MEMORANDUM FOR: J. L. Crews, Director, Division of Resident, Region V
FROM: D. G. Eisenhut, Director, Division of Licensing, NRR
SUBJECT: REQUEST FOR TECHNICAL ASSISTANCE - ALLEGATIONS BY E. EARL KENT
(SAN ONOFRE)

SUBJECT: ALLEGATIONS BY EARL KENT CONCERNING ADEQUACY
OF WELDMENTS AT SAN ONOFRE UNITS 1, 2, AND 3

ATTACHMENT
SOUTHERN CALIFORNIA EDISON
SAN ONOFRE NUCLEAR GENERATING STATION
UNITS 1, 2 AND 3
DOCKET NOS. 50-206, 361, 362
SAFETY EVALUATION REPORT
MATERIALS ENGINEERING BRANCH
MATERIALS APPLICATIONS SECTION

Fig. C8.8.6—Examples of end returns (boxing)

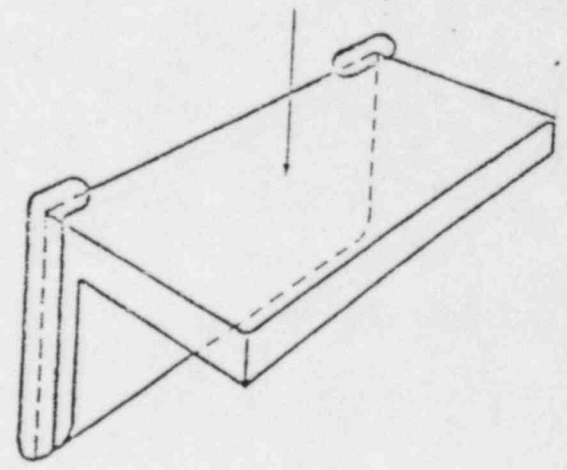
"I am of the opinion that weld end returns are not required on Bechtel drawings. This is in violation of AWS-D1.1, Section 8, 1974 Edition, paragraphs 8.8.6, 8.8.6.1, and 8.8.6.2. These conditions exist on details in many structural applications. A two-page Bechtel Power Corporation table establishes that certain pipe supports and other items must conform to AWS-D1.1 requirements."

"8.8.6 In earlier testing of flexible beam-to-column connections in which the welds were subjected to combined shear and bending, it was found that end returns (hooking the weld) around the top of seat angle connections (see Detail B of Fig. C8.8.6) did not necessarily increase the strength of the connection. In the case of header angles, as shown in Detail A, end returns (boxing) tend to delay the initial tearing of welds under ultimate failure conditions.

This commentary makes note that the ultimate, static load (which is applicable to cable tray hangers and pipe supports at these plants) are not increased by end returns.

In conclusion, the Bechtel Power Corporation showed knowledge of the end return requirements, and used them when there was a design need. Accordingly, this allegation is viewed as not having any merit.
